RE: **2550 NORTH 750 WEST COMMERCIAL SITE**  
**Preliminary Site Plan Review**

Our office has completed a review of the preliminary site plan for the commercial site located at approximately 2550 North 750 West. The parcel has previously been rezoned to CP-2. The proposed plan shows a new 28,000 SF building and associated parking lot per the attached plans. The development will improve the roadway on 750 West and on 2550 North. We recommend preliminary approval at this time with the following comments that will need to be addressed prior to final approval:

# HARRISVILLE COMMERCIAL

RE: **1597 NORTH 750 WEST SITE (ELITE 3 CONSTRUCTION)  
Amended Site Plan Review**

SITE PLAN  
HARRISVILLE COMMERCIAL  
2550 NORTH 750 WEST  
HARRISVILLE CITY, WEBER COUNTY, UTAH

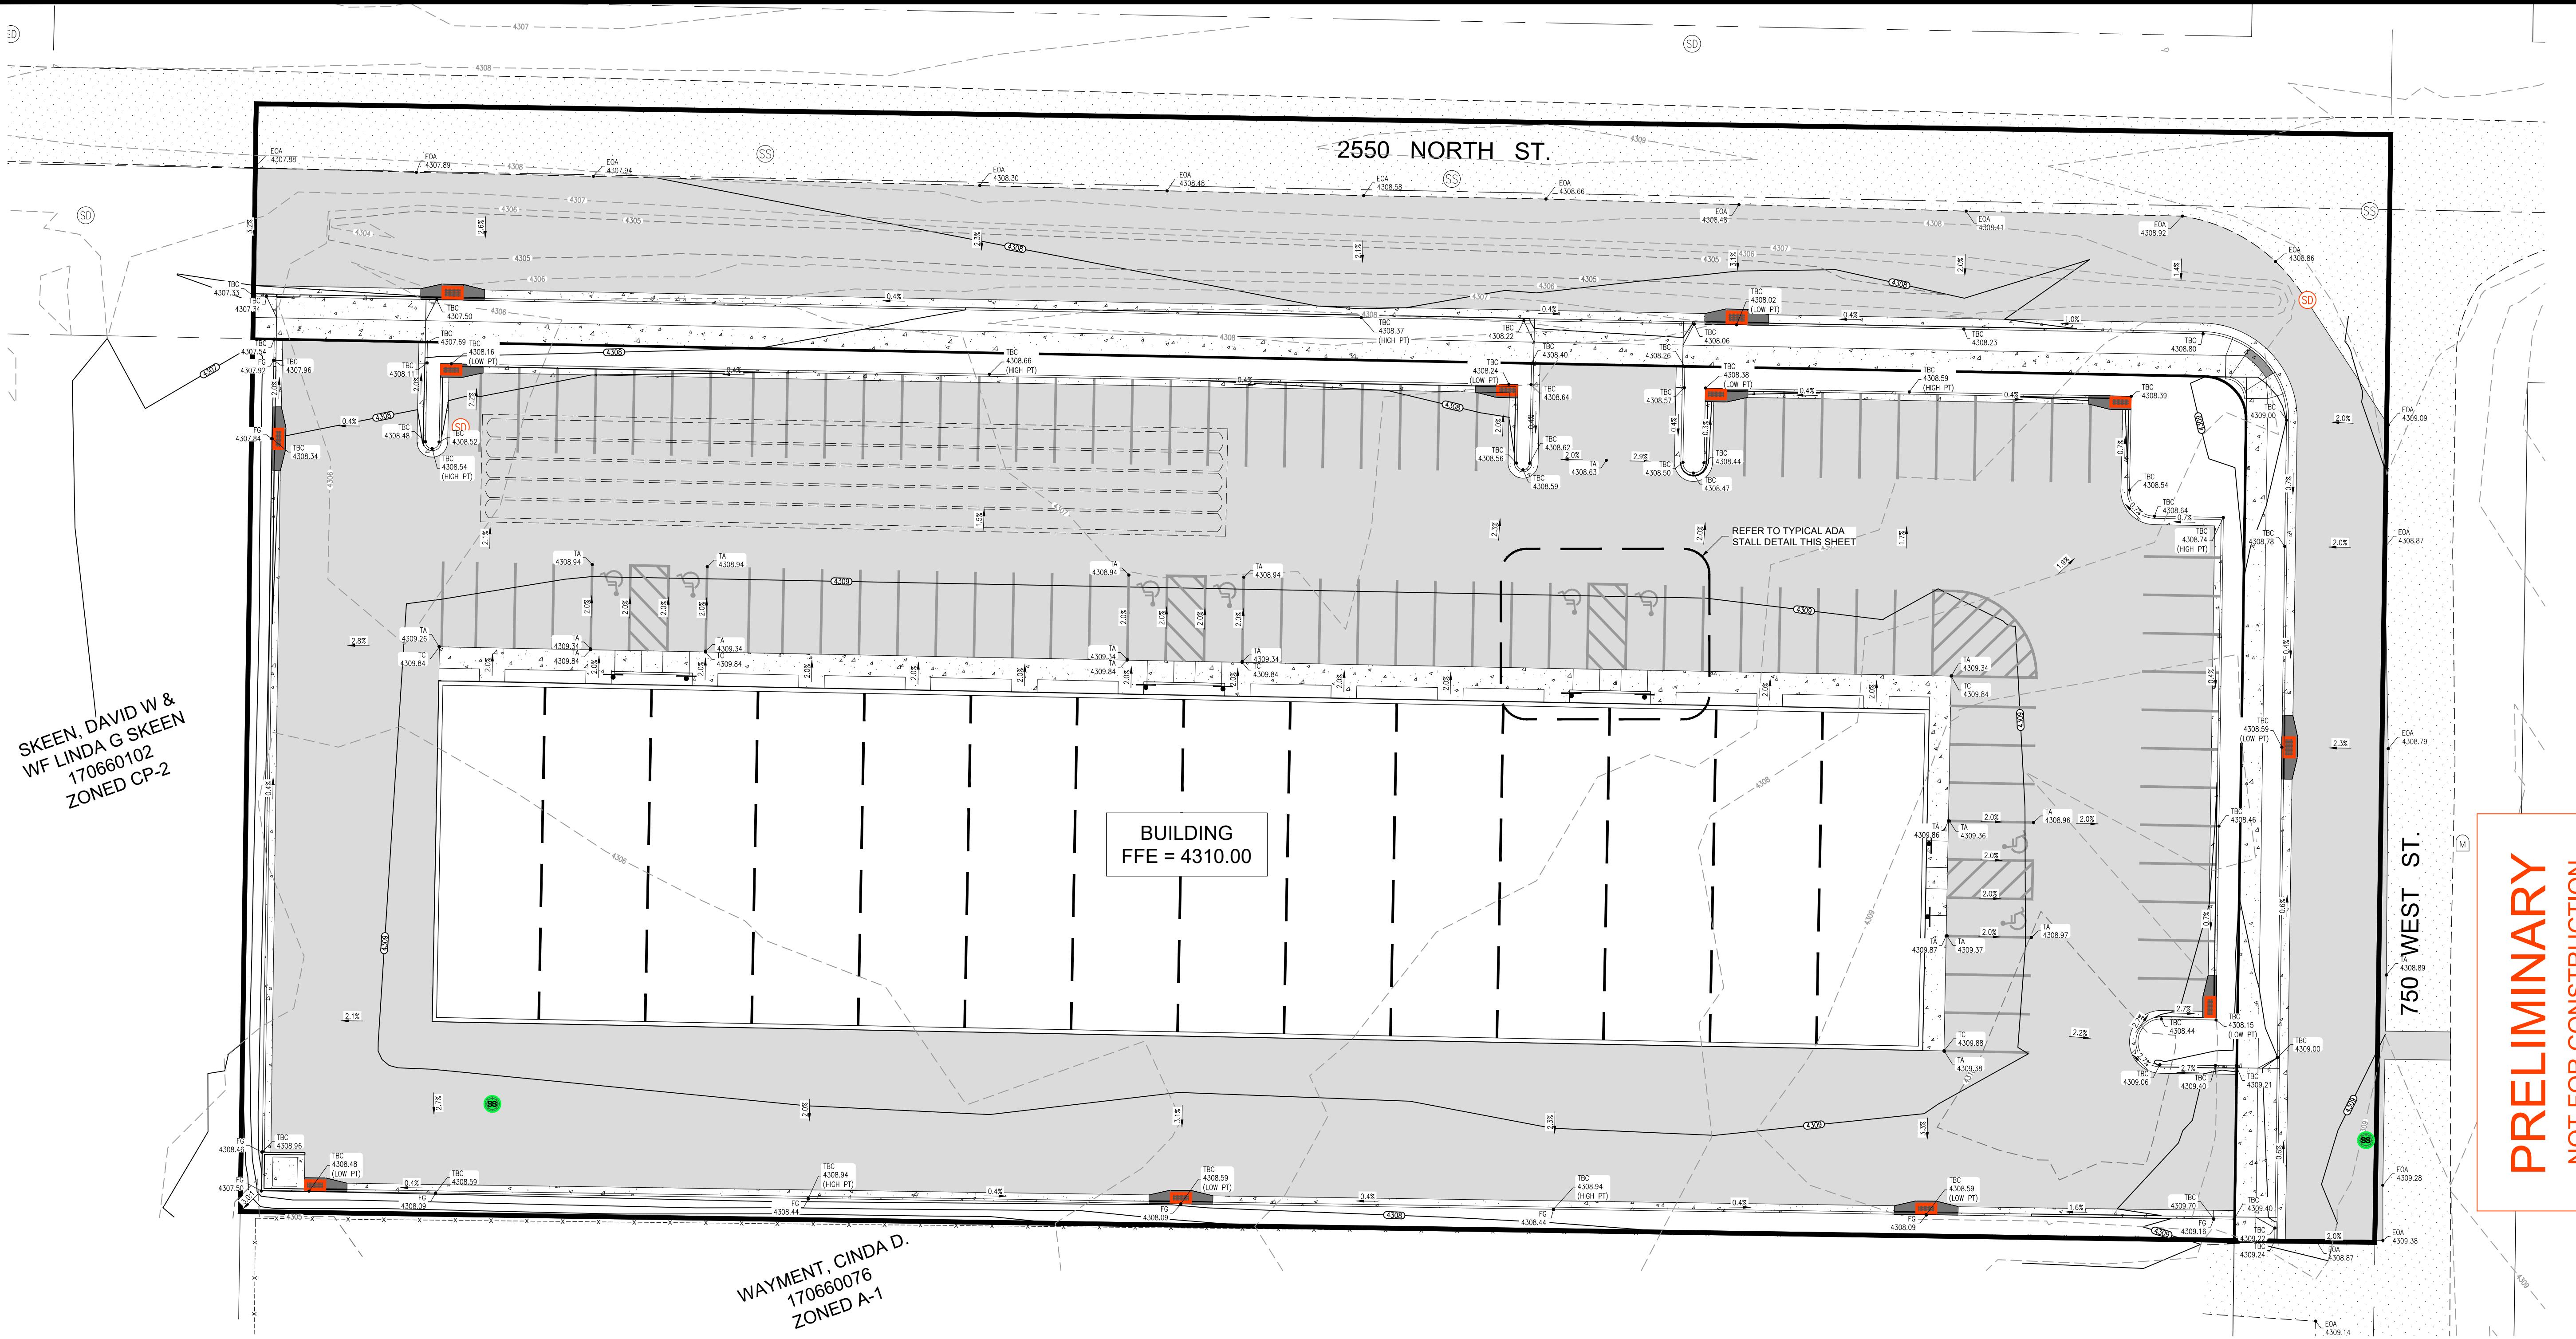
1. Rear parking lot setback should be 15 feet.
2. All improvements along 2550 North will need to be approved by Pleasant View City and will need to follow their standards.

3. Update the pavement section on 750 West to follow the City Standards (4" HMA, 6" UTBC, 12" GB).
4. Provide a landscape plan for the site per city code 11.13.040.

5. Call out the type of fencing shown to ensure that screening requirements are met.
6. Update the storm drain design and calculations to follow the City Standard of an allowable release rate of 0.1 cfs/acre.

7. The trash enclosure floor should be sloped; see city code 11.20.230.
8. The west drive approach on 2550 North and south drive approach on 750 West are too close to the existing drive approaches on adjacent property; see city code 11.13.030. Check Pleasant View code as well for spacing requirements.

# SANO DEVELOPMENT HARRISVILLE FLEX SPACE

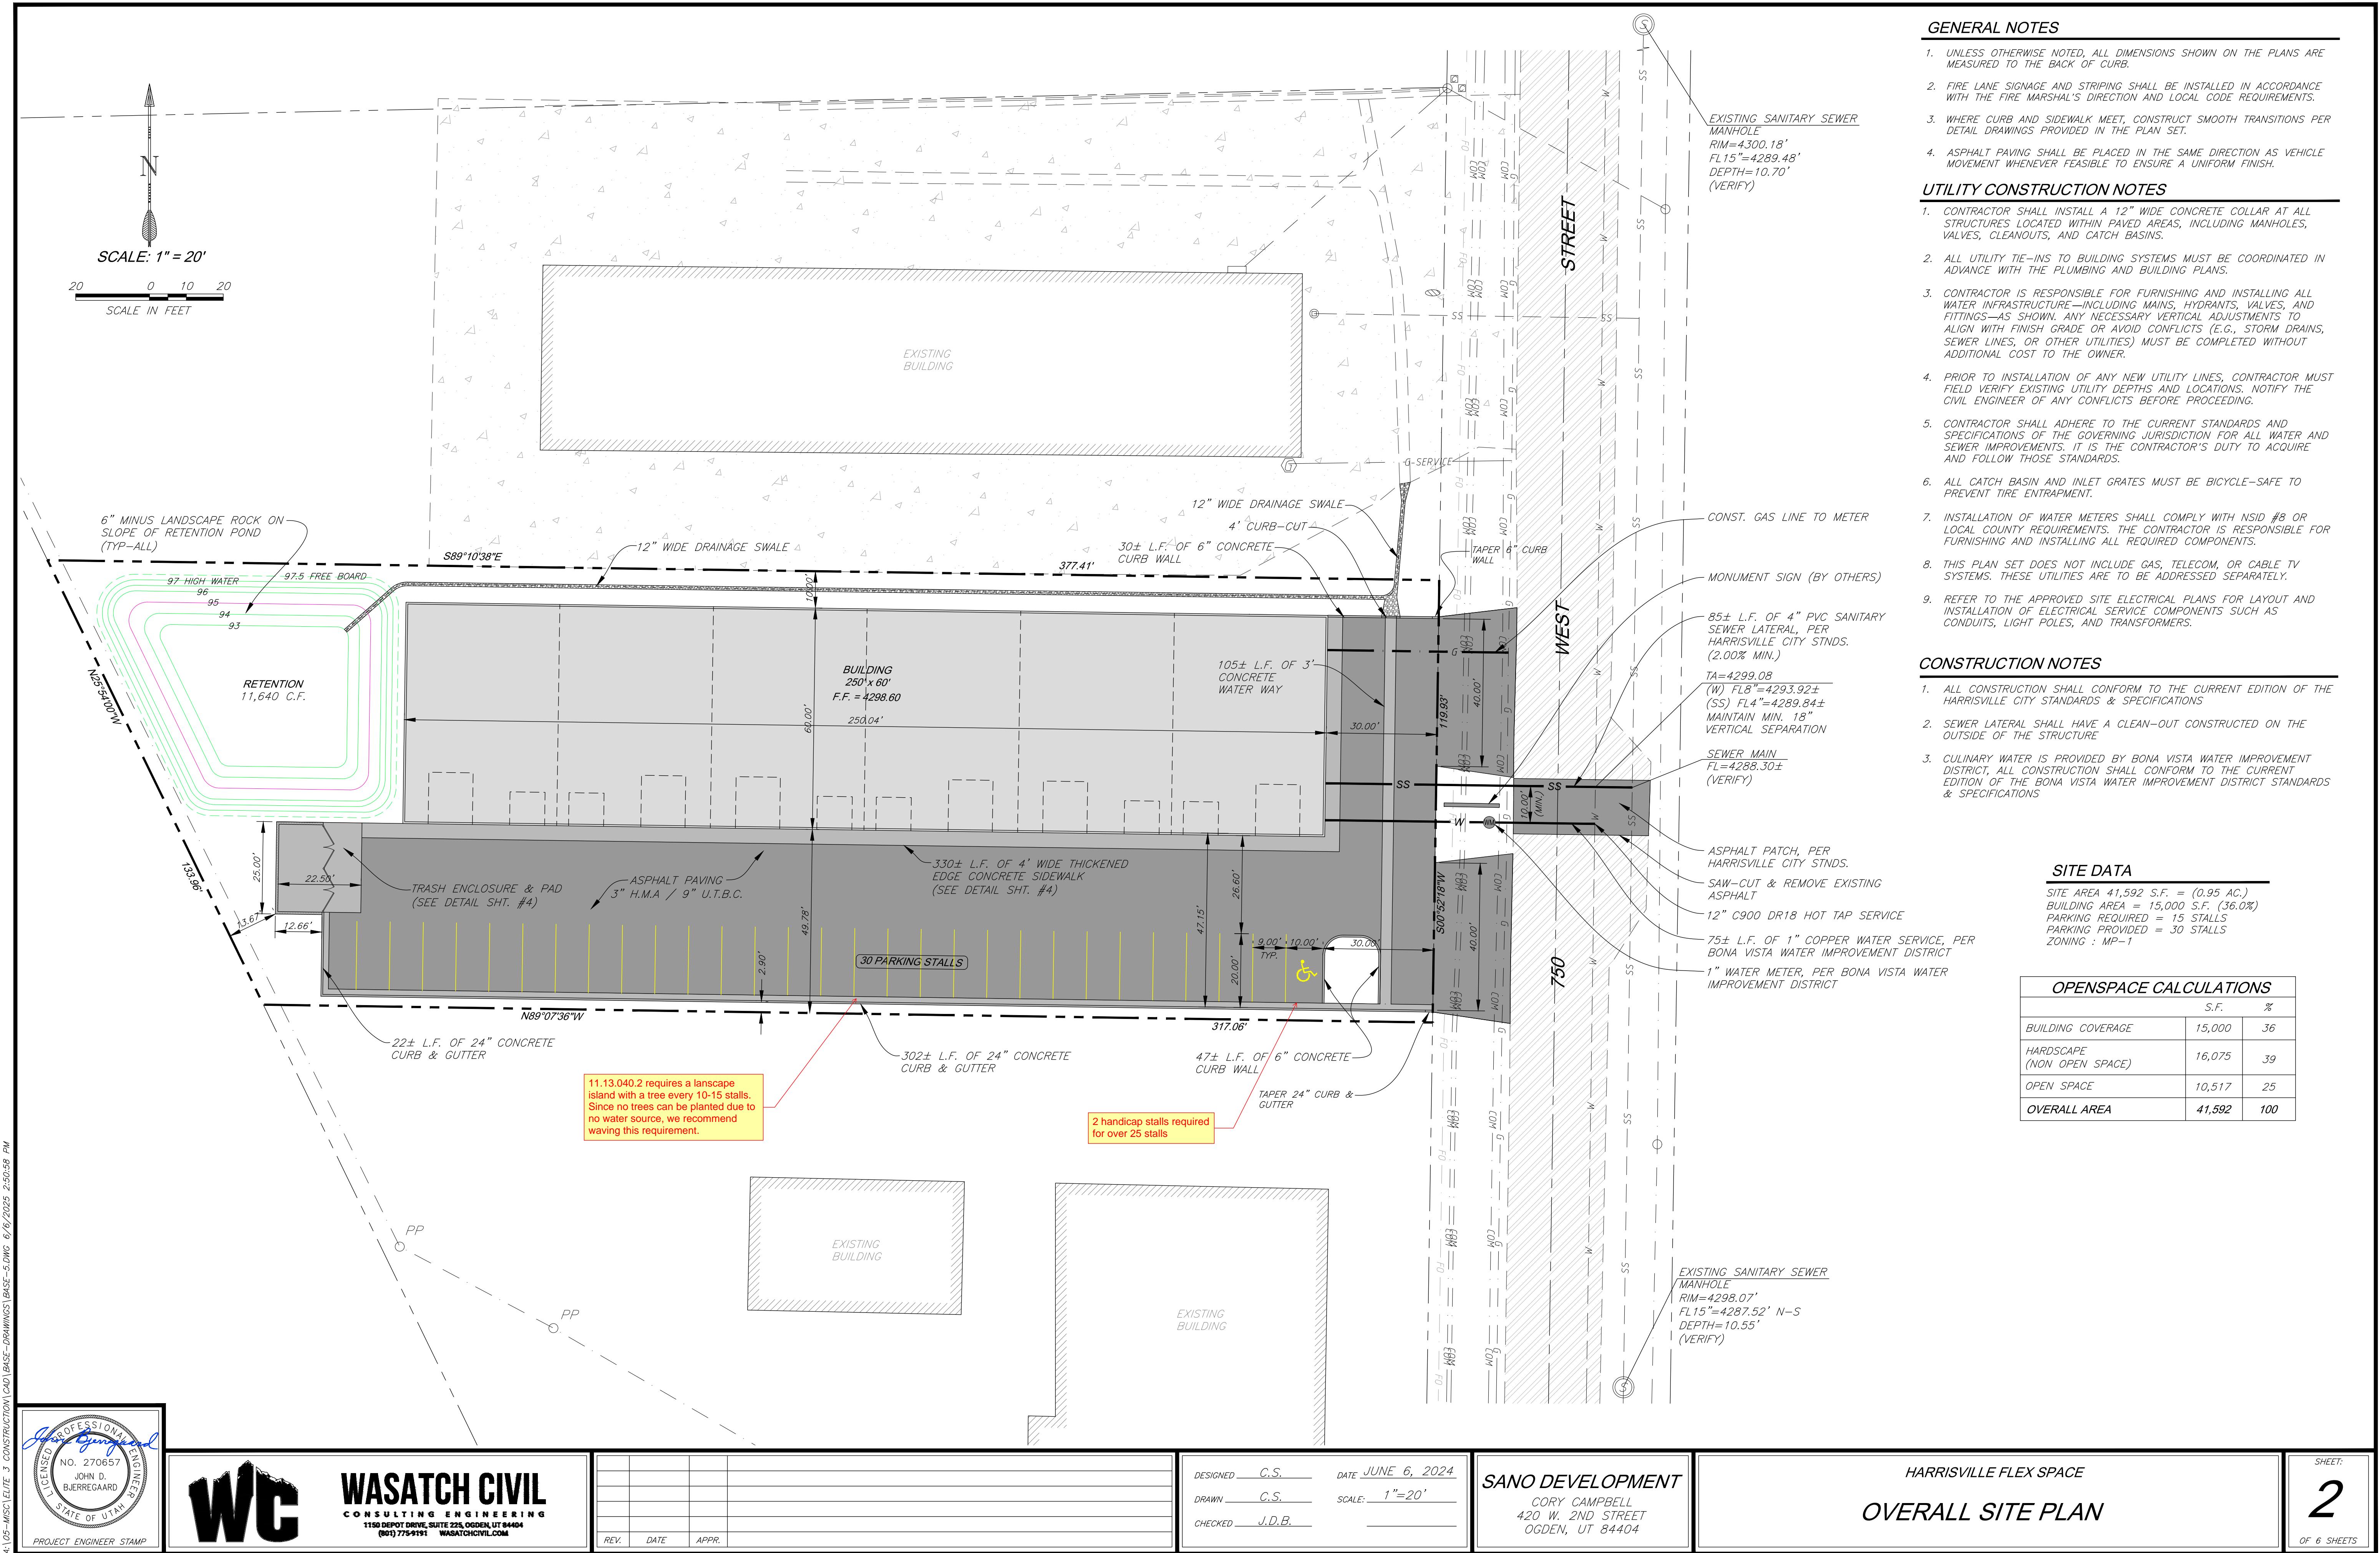
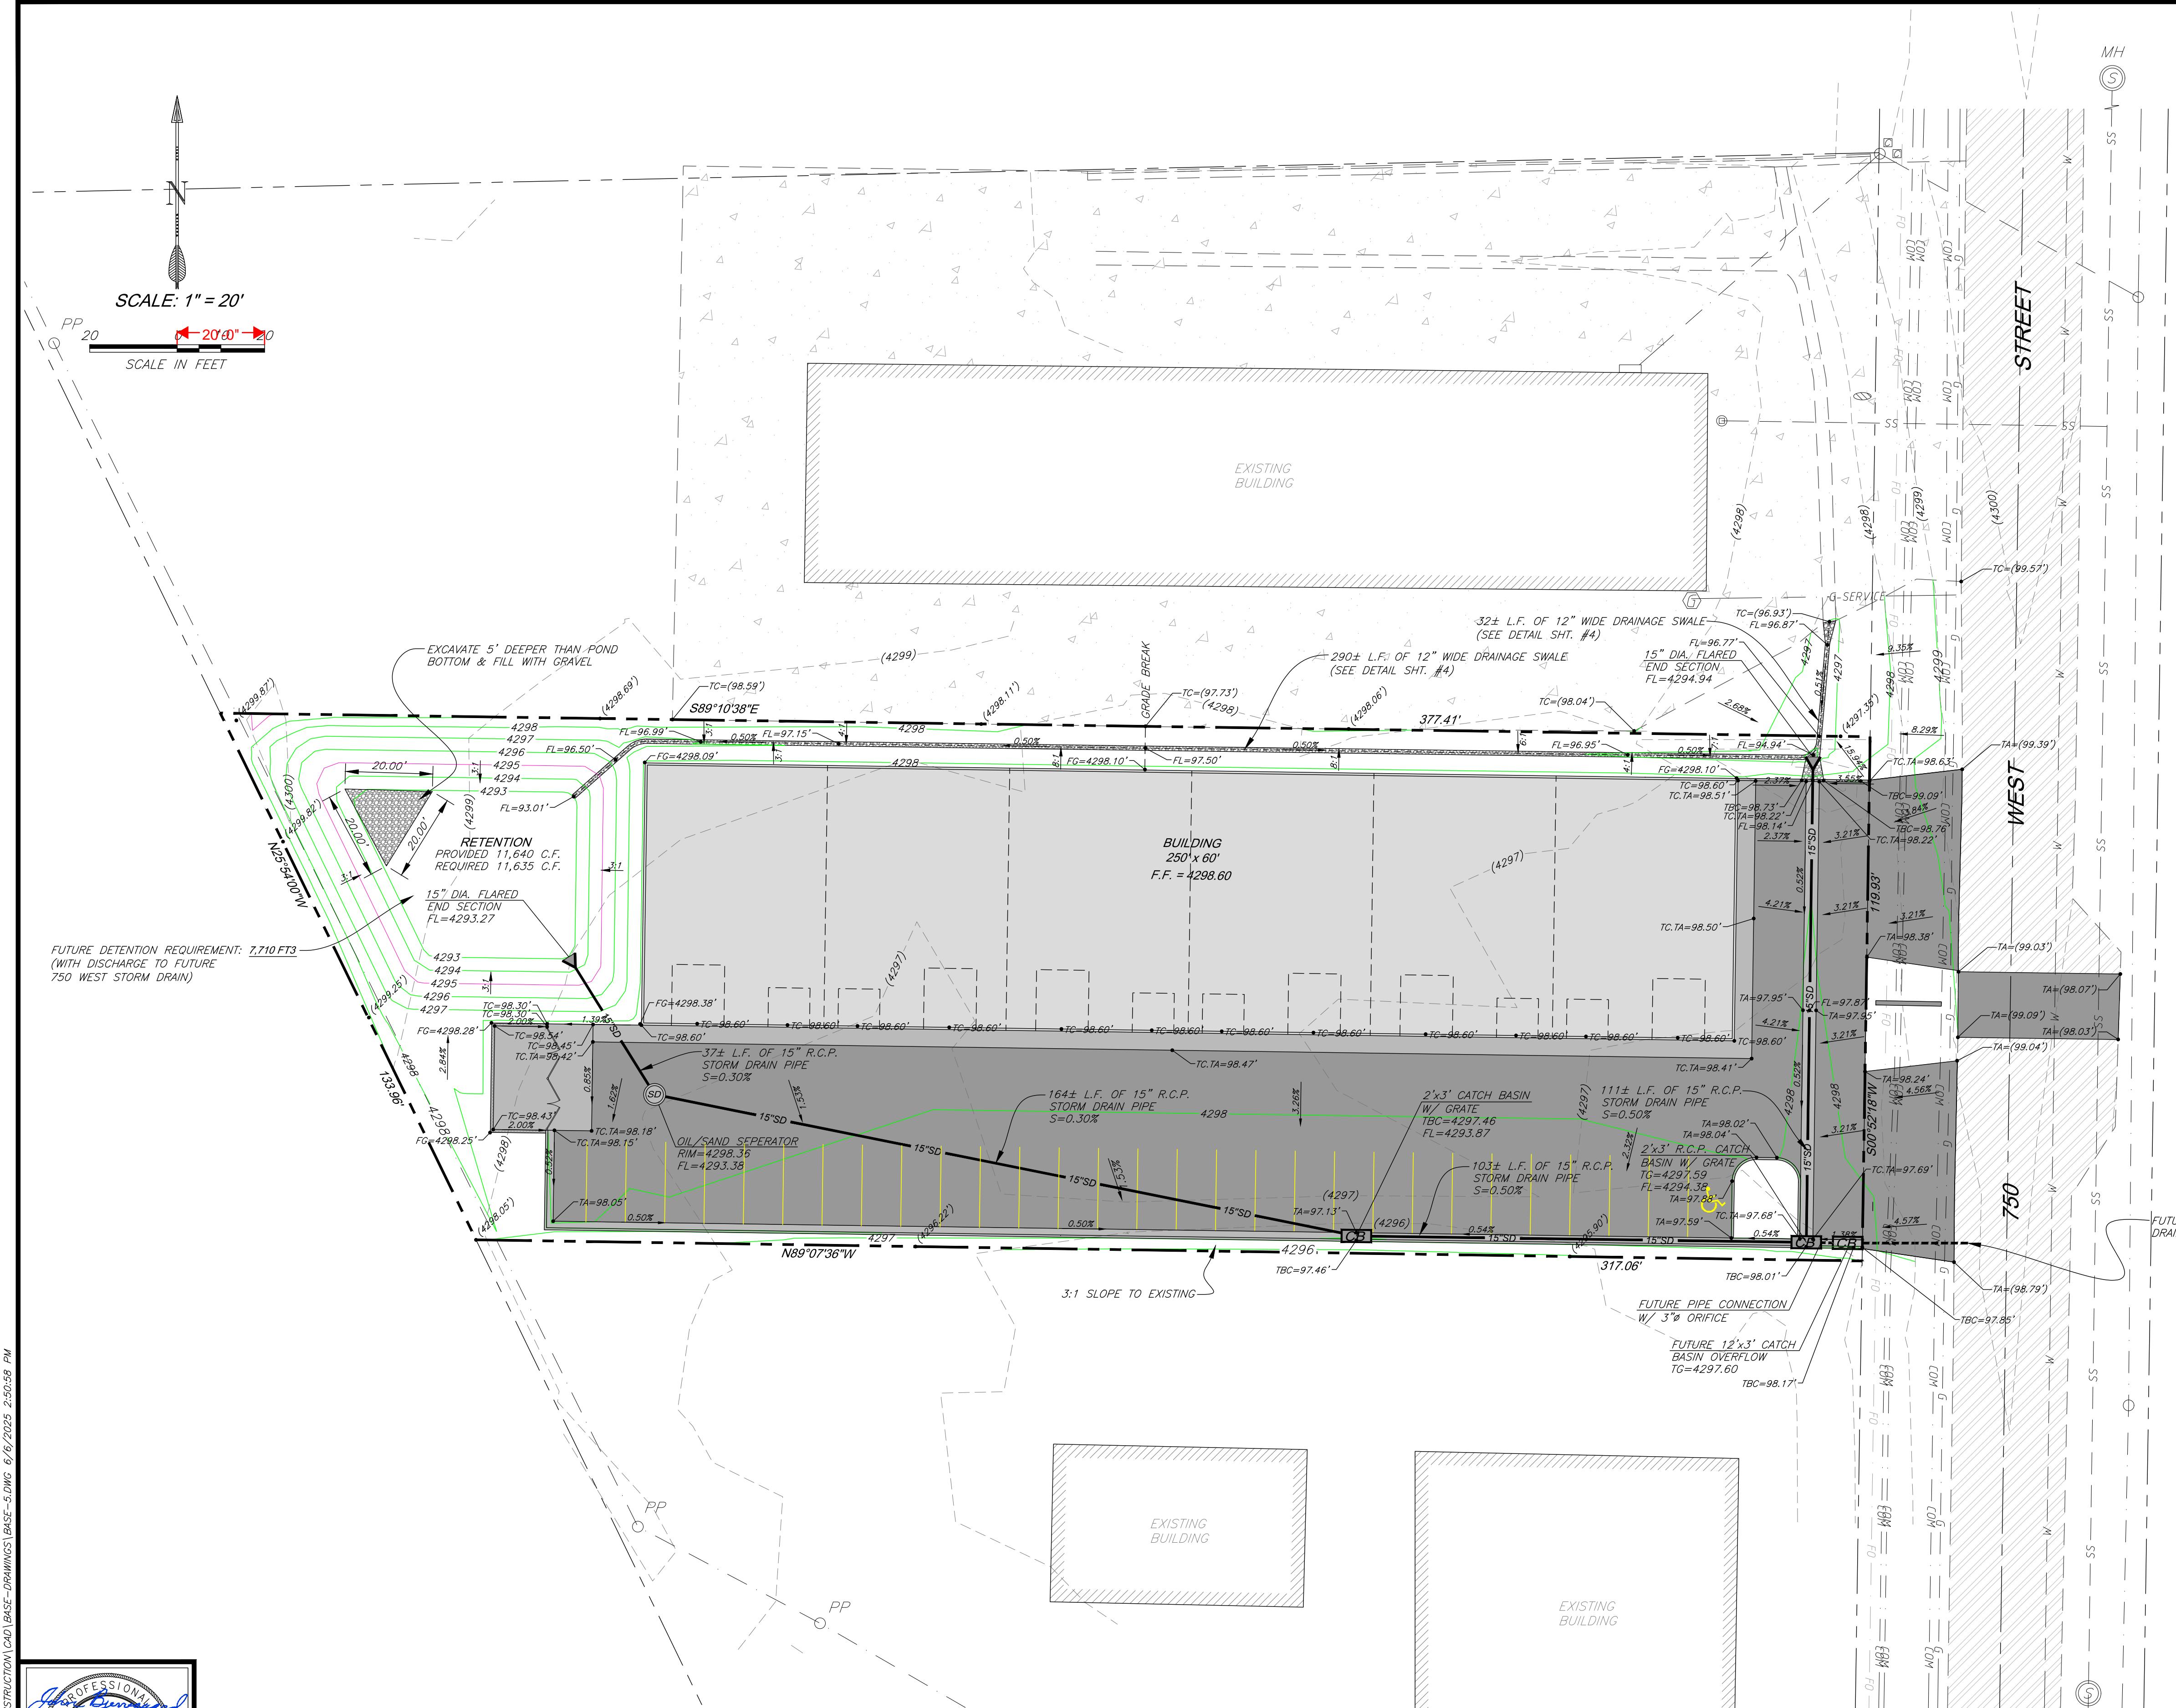
1. Obtain approval from Bona Vista Water for the new culinary water service.
2. Obtain site plan approval from North View Fire District.
3. Provide one additional handicap parking stall per 11.13.030.e of the city code.
4. The landscaping plan calls for decorative rock placed over a weed barrier fabric. No plants or trees are shown because outdoor watering is not allowed by Bona Vista and no secondary water service is available in this area. We recommend waiving the requirement to have living plants in the landscaped area due to this limitation.
